TESLA	Tesla, Inc. Service Bulletin		Reroute Main Front Body Harness				
SB-20-17-004 April 23, 2020		R1					
Classification			Section/Group	Mobile Service			
Campaign Bulletin			17 - Electrical	Can Perform (where permitted)			
Model Yea	ar Model		Country/Region	Version			
2017 - 2019	Model X		All	All			
The model(s) and model year(s) listed are a general approximation of the affected VIN list. Refer to the VIN/Bulletin Tracker or Customer/Vehicle profile to determine applicability of this bulletin for a particular vehicle.

On certain Model X vehicles, the main front body harness might contact the RH front upper control arm.

Figure 1

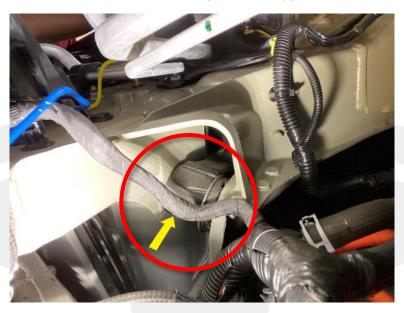
- 3. Inspect the fuse box harness branch at the main front body harness near the RH front upper control arm for damage (Figure 1):
 - If there is no sign of the harness contacting the RH front upper control arm, or if the harness is contacting the RH front upper control arm but the insulation of the wires is still intact, continue to the next step.
 - If any of the harness wires are damaged or exposed, repair the harness. Refer to <u>SI-17-17-002</u>, "Electrical Harness Repair" for further instructions on how to repair the wire(s), and then continue to the next step.

Figure 3

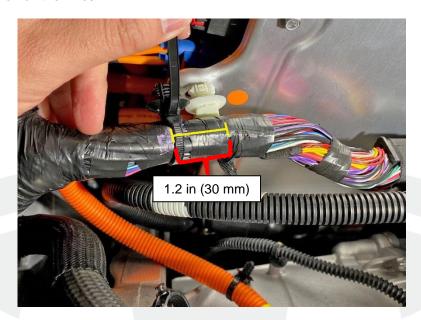
- 5. Install the new cable tie/clip onto the main front body harness 1.2 in (30 mm) right of the fir tree clip (Figure 3)
 - NOTE: The new cable tie secures the main front body harness further from the RH front upper control arm without putting tension on the wires.
